# Cambourne to Cambridge: In-Highway Proposals for High Quality Public Transport Scheme

*Produced for Cambridge Past, Present & Future  
by Edward Leigh MA MSc, February 2021*

Figure 20: Reassignment of hatched outside lane on A428 at the Girton Interchange to create a 640m long bus and coach lane

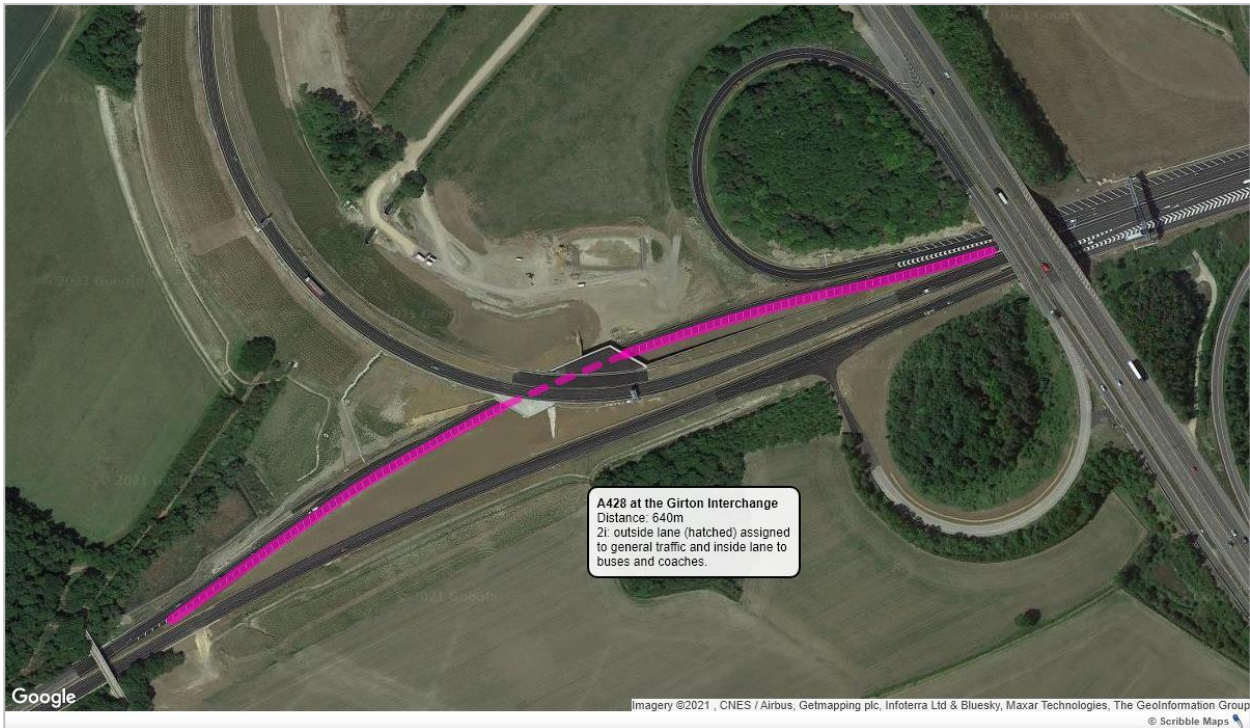
**2j. Reassign hatched carriageway on A428:** Moving the general traffic lane into the offside hatched area would free up the inside lane to be used by buses and coaches (and emergency vehicles). If the lanes merge before the M11 overbridge, this would provide a 640m bus lane to bypass congestion (see Figure 20).
